**PROPOSED FINDINGS SUSTAINING THE APPEAL OF
PEARL DISTRICT NEIGHBORHOOD ASSOCIATION
LU 16-278621 DZM GW
PC #16-262122
(Fremont Apartments)**

I. INTRODUCTION

This matter is before us on appeal of the Design Commission's approval of the Fremont Apartment project under the Design Review and Greenway development criteria discussed below. In summary, the applicant seeks a number of modifications to our standards in order to justify the requested height, F.A.R., siting, and massing of this riverfront project, as well as the nature and placement of the required public amenities.

Figure 1. TVA Architect's Rendering of Two Versions of Fremont Apartment Massing

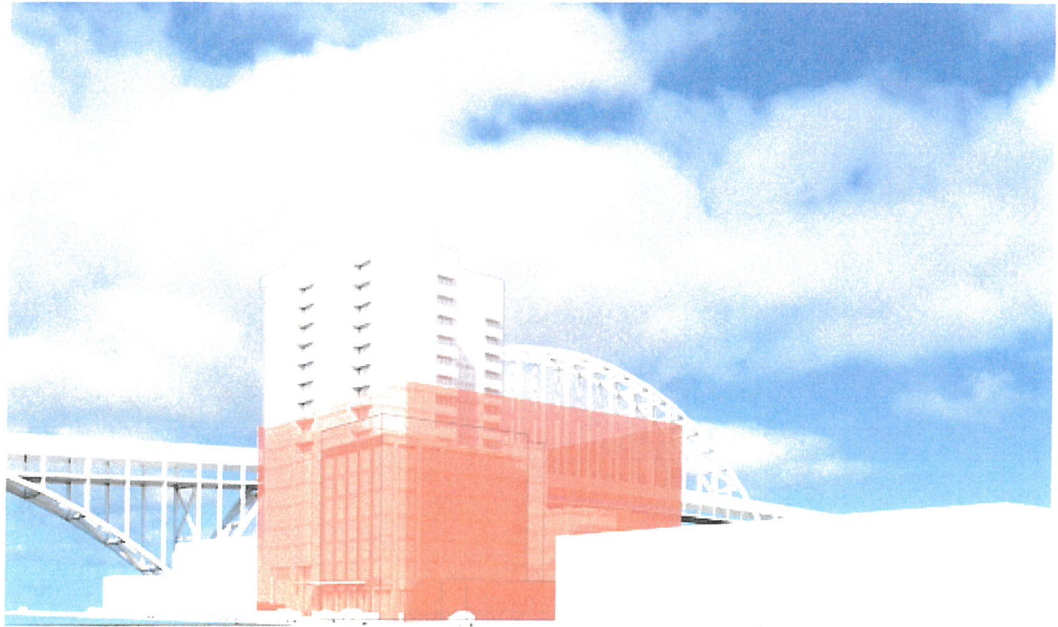
The staff’s use of language here is highly misleading. The view of the bridge is only “opened back up to the Fields Park” *compared to the initial proposal*. The revised (and approved) *proposal, far from offering “open” views, merely blocks a different part of the view!* The misleading language of the BSM staff cannot obviate the fact that the Design Commission erred in granting Modifications #1, #3 and #5 because they are in direct violation of the purposes of Zoning Code 33.510.205.H.2.

Figure 1. shows two versions of how the Fremont Apartments could be massed, as proposed by the developer’s own architects. Essentially, the developer has said, “We can obstruct the view either by massing the building as a cube (shown in orange), or by rearranging it as a tower (shown in white); which obstruction do you want?” The Design Commission chose the latter. This was a false choice—one that the Commission should not have been forced into—had the correct bases for calculating allowable building mass been applied, as I will amplify in my last point below.

Figure 2. Projected Long-Term Development Pattern in North Pearl Subarea if Fremont Apartment Proposal is Approved

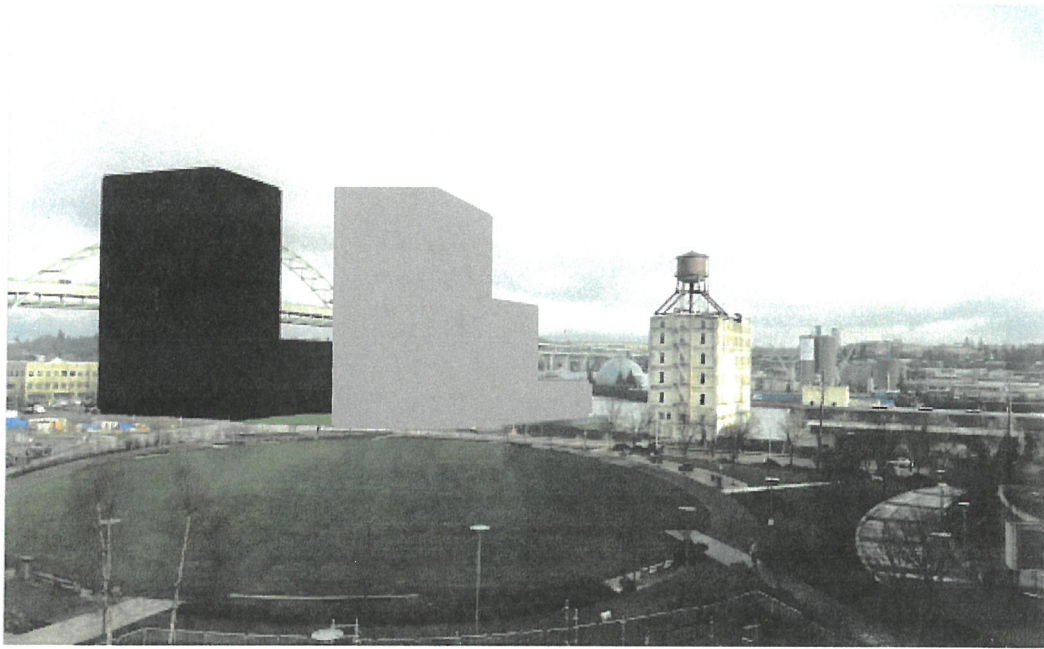
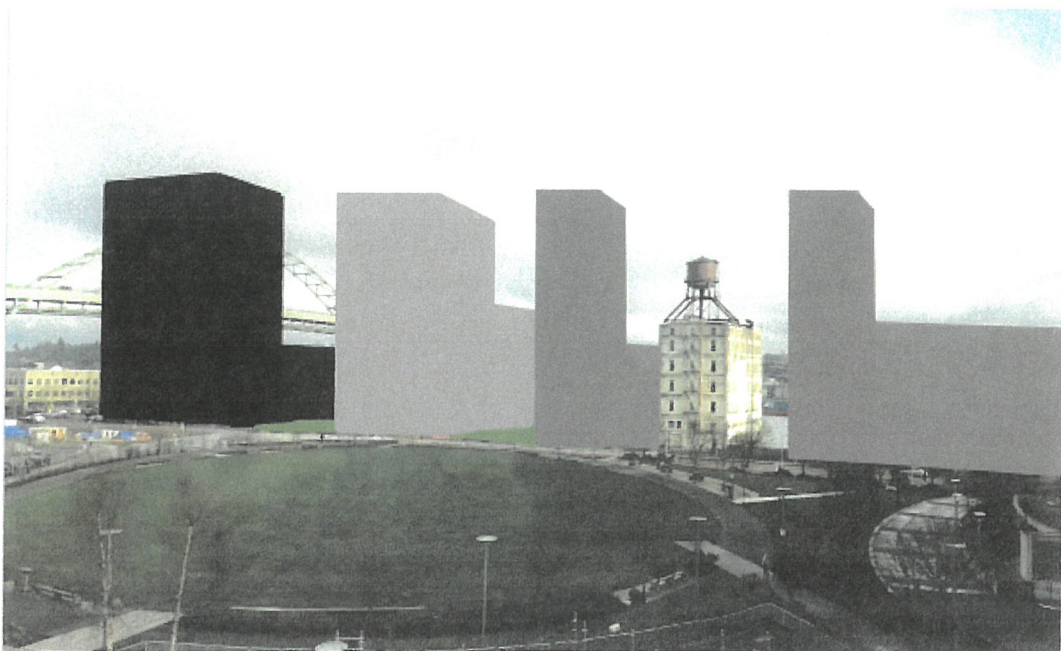
What the dangerous precedent set by the Design Commission's decision might produce is portrayed in Figure 2. Figure 2A shows the current view of the Fields Park, Fremont Bridge, Willamette River, and Centennial Mills development site. Figure 2B shows how this picture would be degraded if the Fremont Apartments were built in the approved configuration. Figure 2C shows what would happen if a developer of the site immediately south of the proposed Fremont Apartments constructed a residential tower of approximately the same mass. Figure 2D shows what would happen if a developer of the Centennial Mills site constructed another residential development of approximately the same mass.

Figure 3. Consequences of Miscalculating Base Floor Area for Building Mass

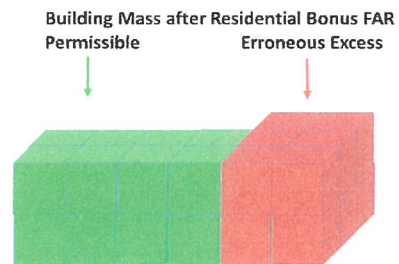
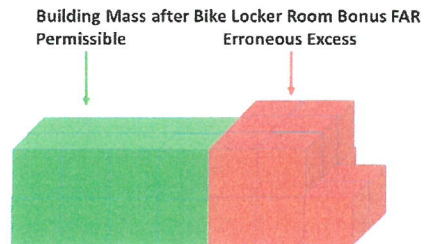
The difference is portrayed visually in Figure 3A-F. Let each square represent 10,000 square feet. Figure 3A portrays in green the approximate base floor area of the Fremont Apartments, had proper zoning code measurements been applied. Figure 3B shows that the developer’s erroneous calculations resulted in an excess, impermissible area of about 30,000 additional square feet (shown in red). The remaining panels of Figure 3 show the consequences of this error when zoning regulations are applied. The area has baseline zoning of 2:1 floor area ratio (FAR), which means that the base floor areas get doubled when specifying permissible building volumes; see Figure 3C showing permissible mass.

The Design Commission compounded the error by granting at its discretion a 1:1 FAR bonus for all areas of the building that are residential, which is permitted but not mandated by Zoning Code.²⁸ Assuming for simplicity that all the areas shown will be residential, the building will again double its permissible mass; see Figure 3D.

The Design Commission further compounded the error by granting the developer yet another, discretionary FAR bonus for a locker/shower room for cyclists.²⁹ Such a bonus was clearly intended in the code for commercial/retail structures only. This inappropriate bonus added still more volume and mass to the building (15,200 cubic feet), as shown in Figure 3E.
